Triangle Place, JSP13-53

Consideration of the request of Trowbridge Companies for Preliminary Site Plan and Stormwater Management Plan approval. The subject property is located in Section 36, on the east side of Haggerty Road, north of Eight Mile Road in the B-3, General Business District (with a Planned Rezoning Overlay). The subject property is 0.48 acres and the applicant is proposing a 2,420 square foot speculative office and retail building.

PLAN REVIEW CENTER REPORT

**SUBJECT: Triangle Place / Haggerty Retail Development, JSP13-0053,
Traffic Review of Preliminary Site Plan, PSP13-0122, and Final Site Plan, PSP13-0123**

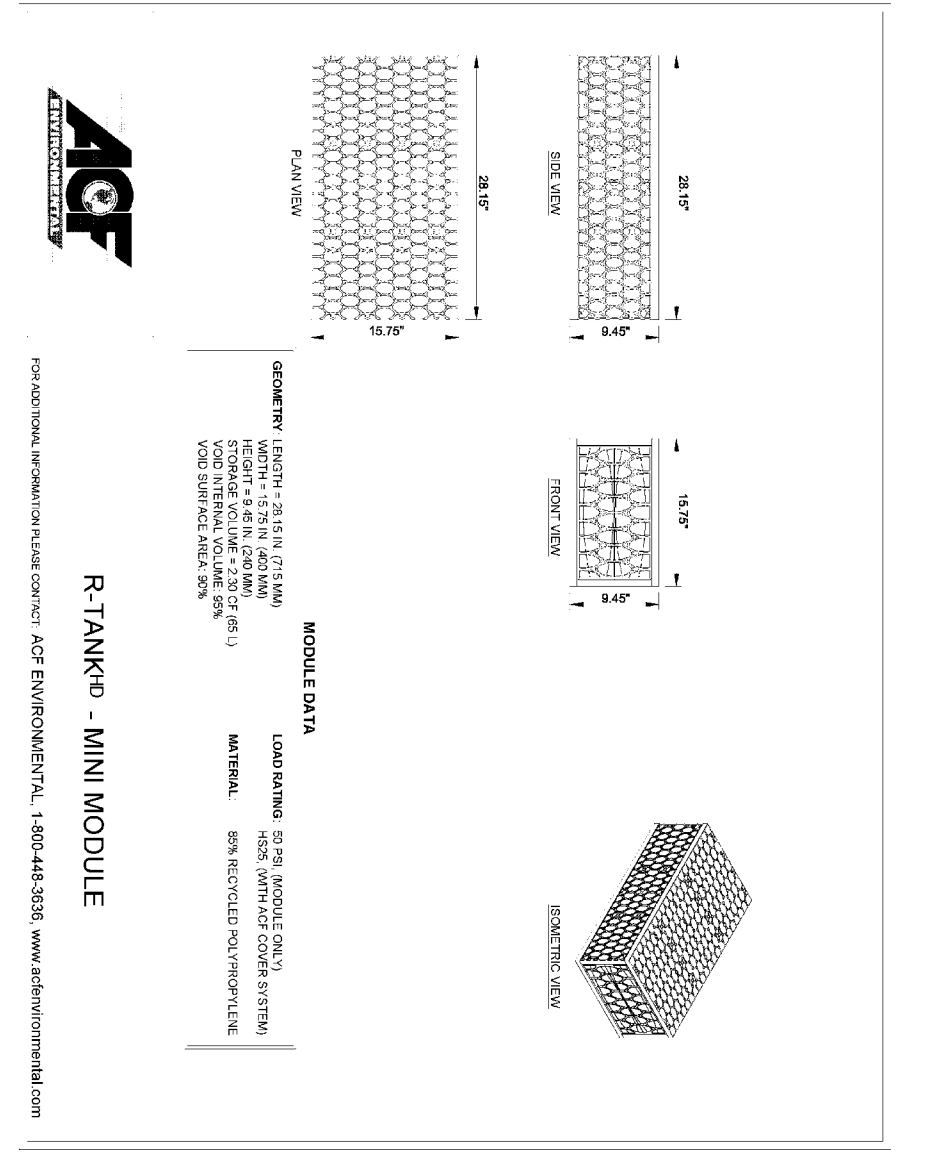
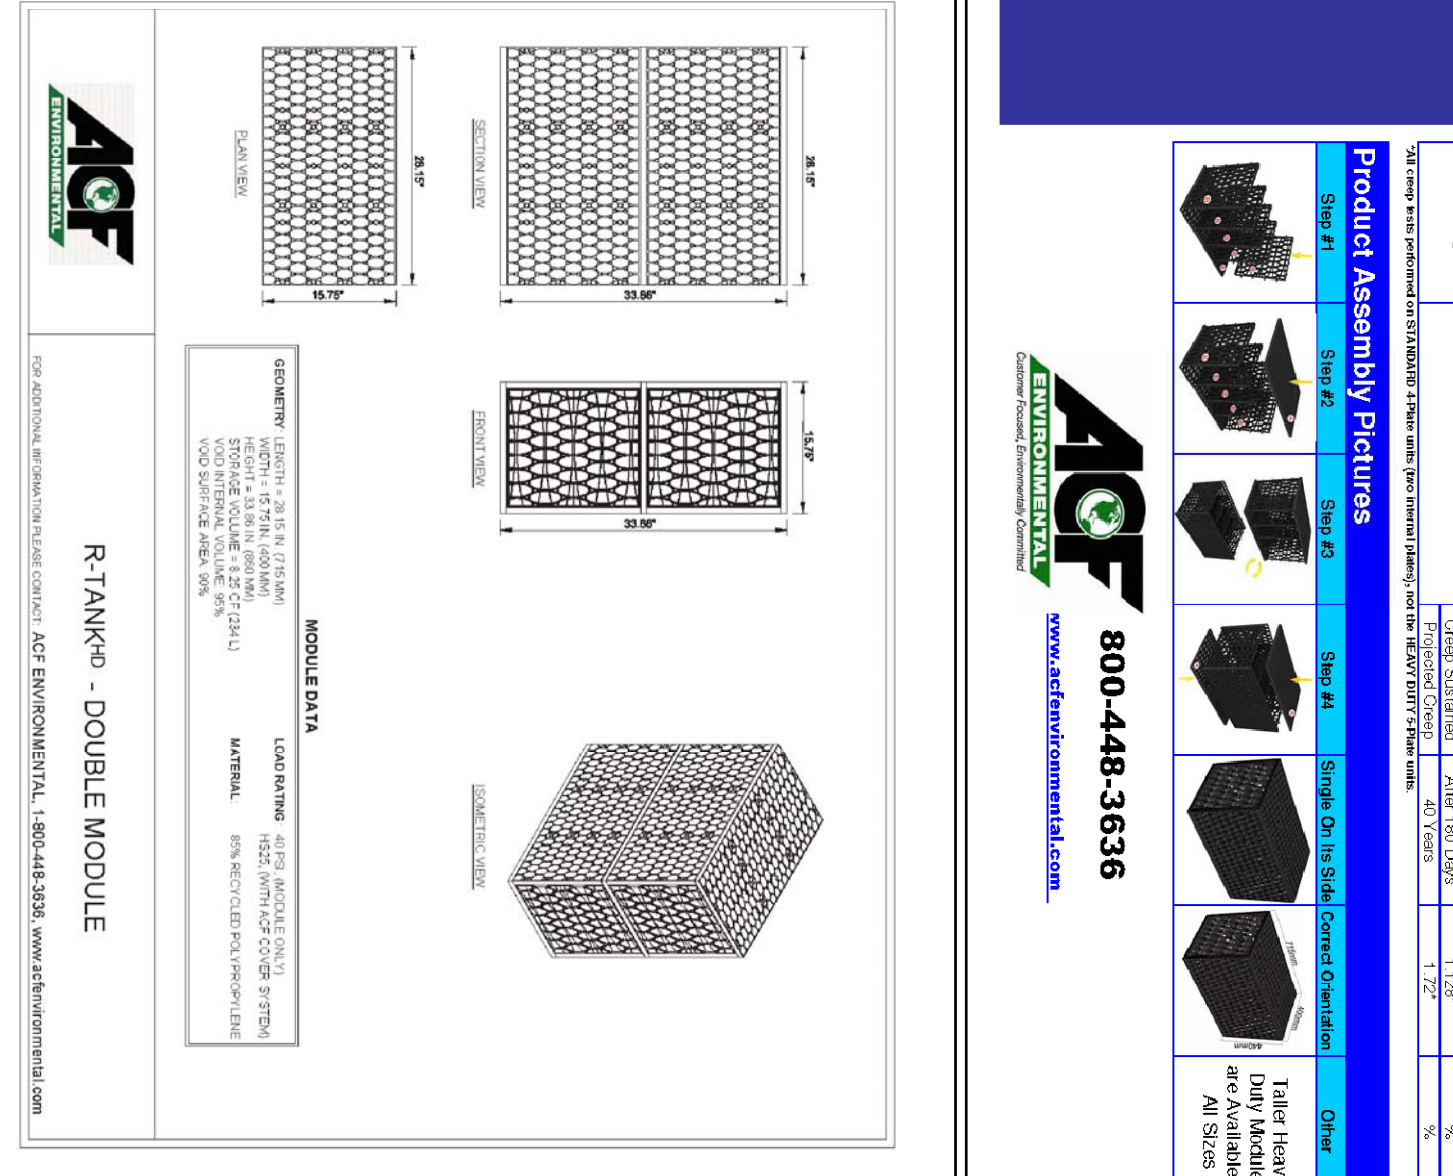
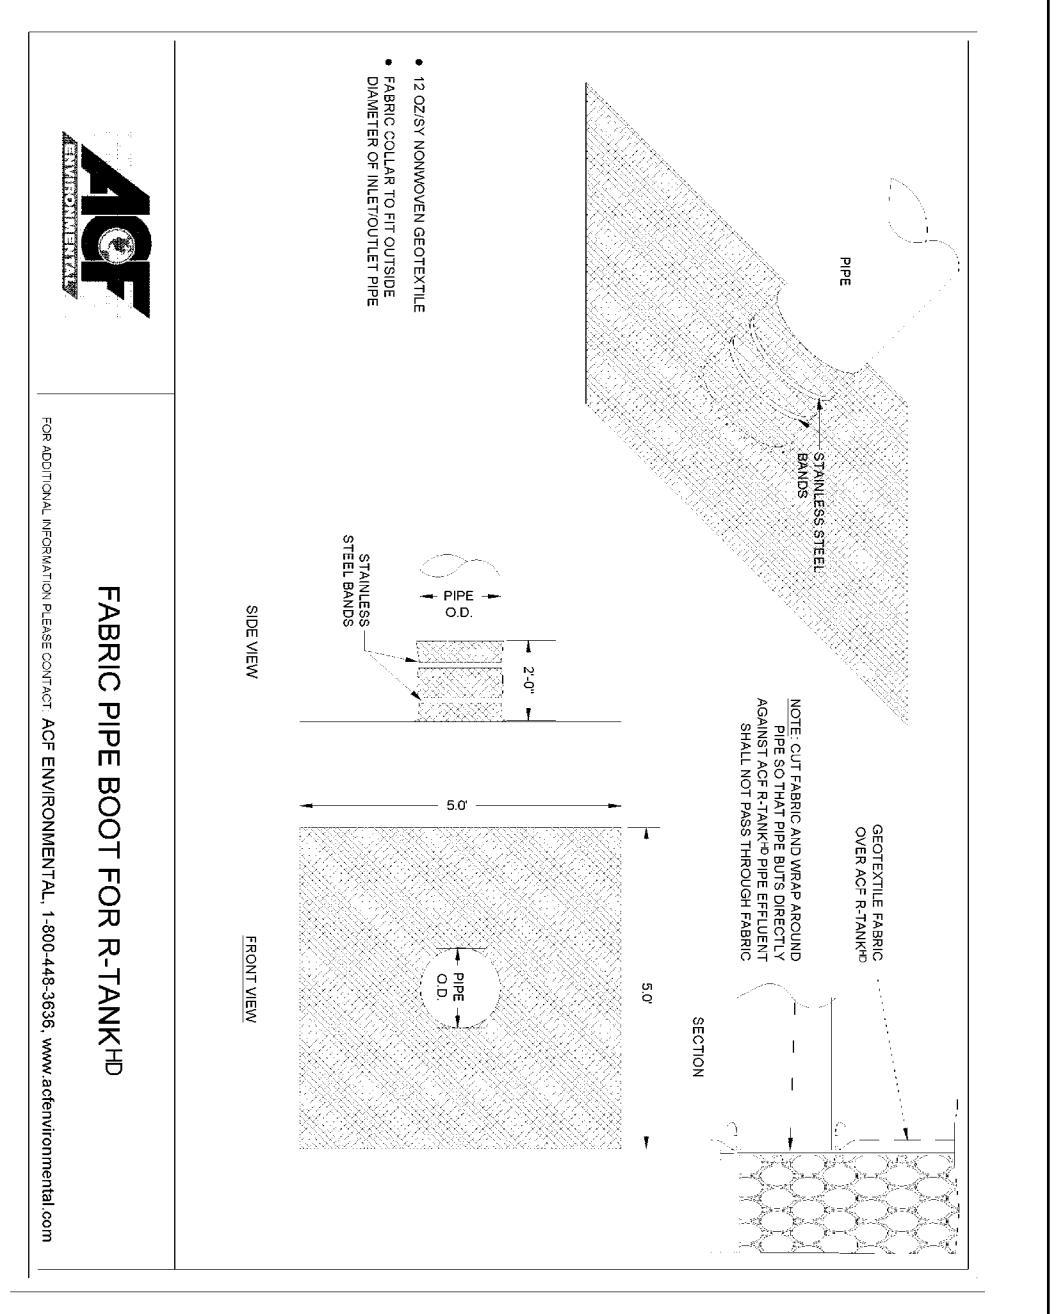
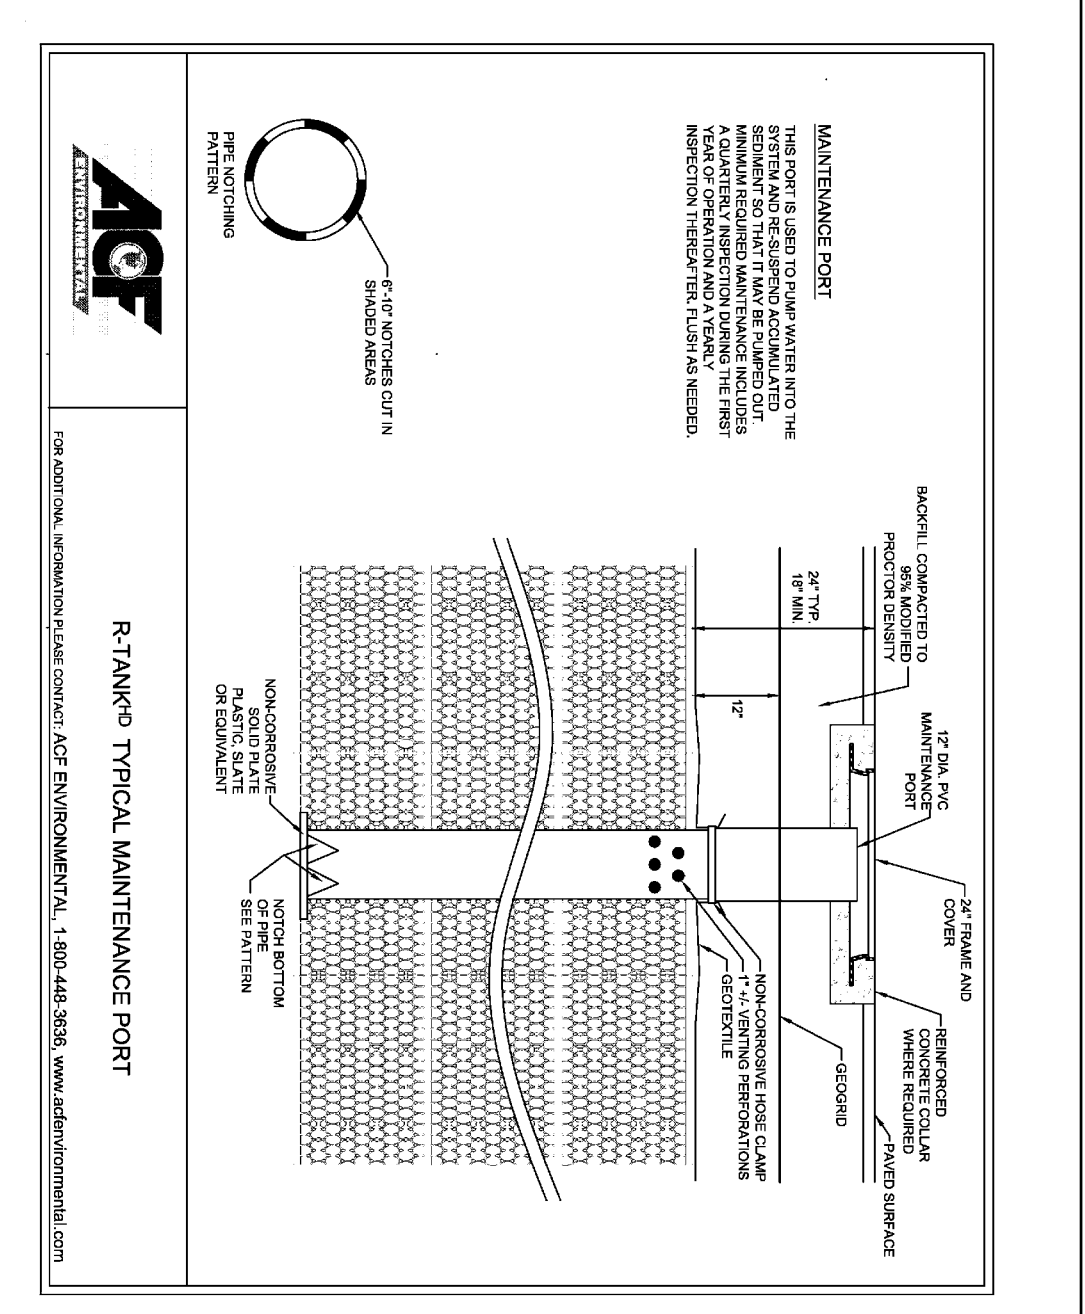
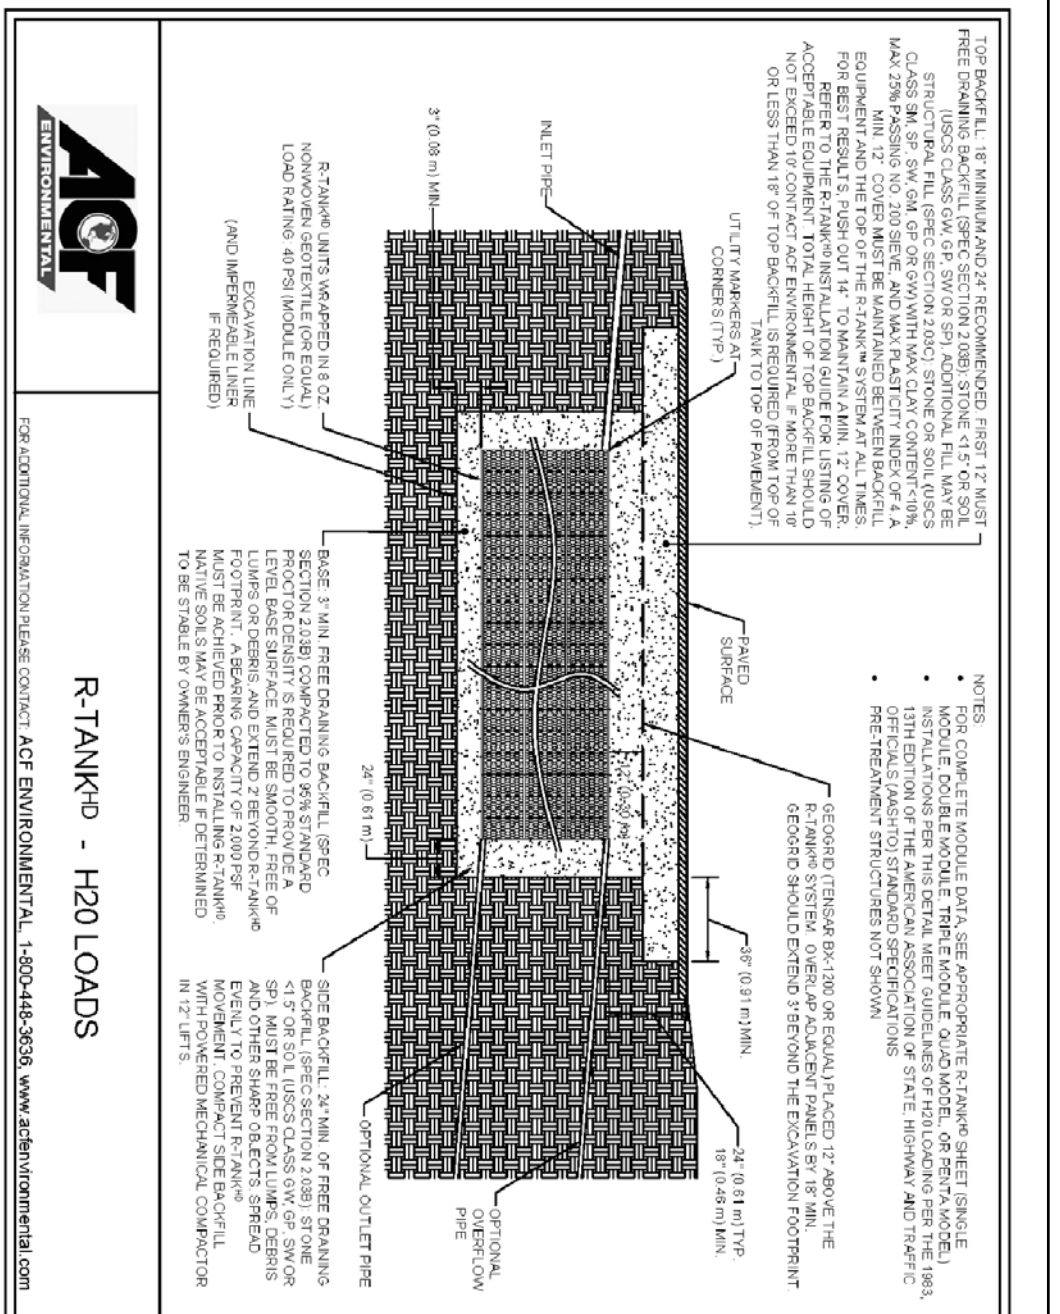
16. Revise the drainage coefficient for all impervious and turf lawn areas to 0.95 and 0.35, respectively, versus 0.9 and 0.2 as provided.
17. Revise the underground detention system to provide open chambers or runs of pipe to accommodate a 100-year storm event. Modular cell systems are not an approved means of providing underground detention.

20. Provide critical elevations (bankfull and 100-year storm hydraulic grade lines) on the underground detention system cross-section and storm sewer profile demonstrating that the detention system is 3 feet above ground water and has the required 1 foot of freeboard between the high water elevation and the subgrade below the pavement.

project location:
Haggerty Road
City of Novi, Michigan
sheet title:
Landscape Plan

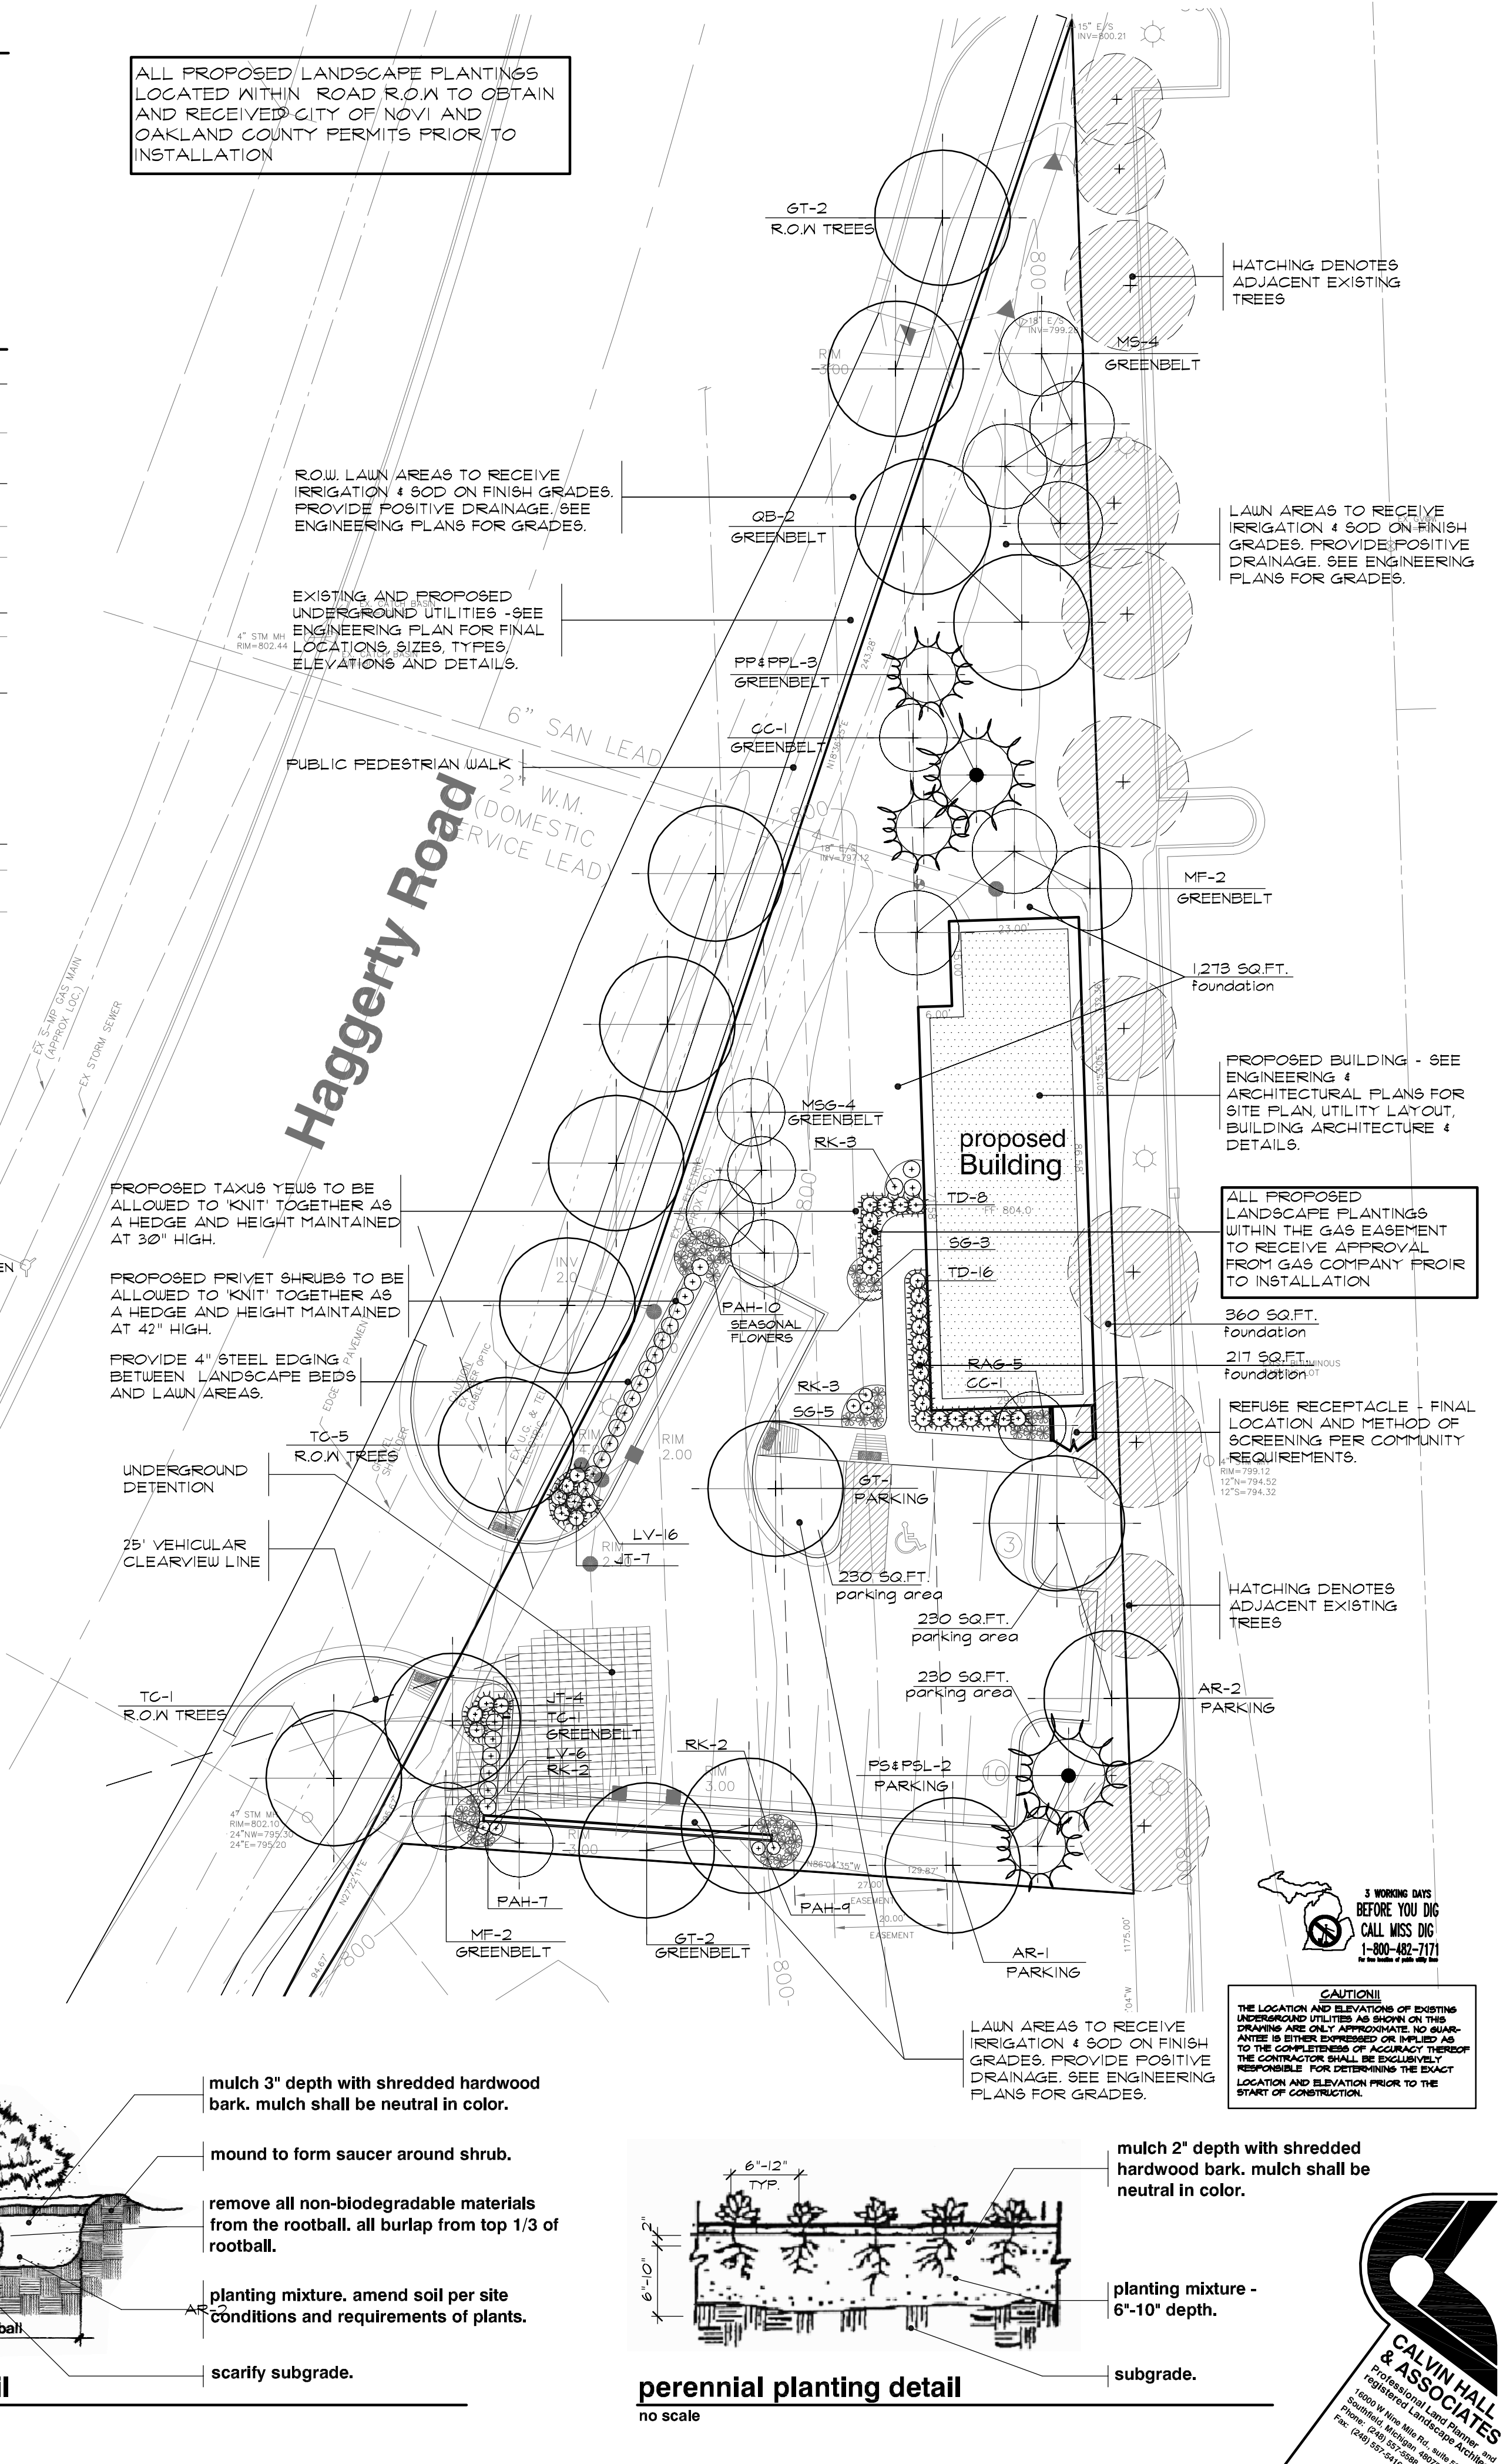
3. The developer agreed to provide additional landscaping along the adjacent property to the south. ***This has not been included on the landscape plan and must be provided with the next plan submittal.***

1. A 3' tall landscape buffer berm is required along the Haggerty Road frontage. Please depict the berm on the landscape plan.
2. The Landscape Design Manual requires shrub plantings on buffer berms to be staggered in a minimum two rows. Please adjust the plantings and add plants as necessary.
3. One canopy tree per 40 l.f. is required along the berm area. This requirement has been met.
4. One subcanopy tree per 35 l.f. is required along the frontage of Meadowbrook Road. These have been provided.

1. One street tree is required per 45 l.f. of road frontage. This requirement has been met directly on the project site. However, a stipulation in the PRO agreement called for the extension of the sidewalk and street tree plantings from the southern boundary of the site to the next intersection. This extenuation has not been shown. Please include the extended sidewalk and street tree plantings on the landscape plan.
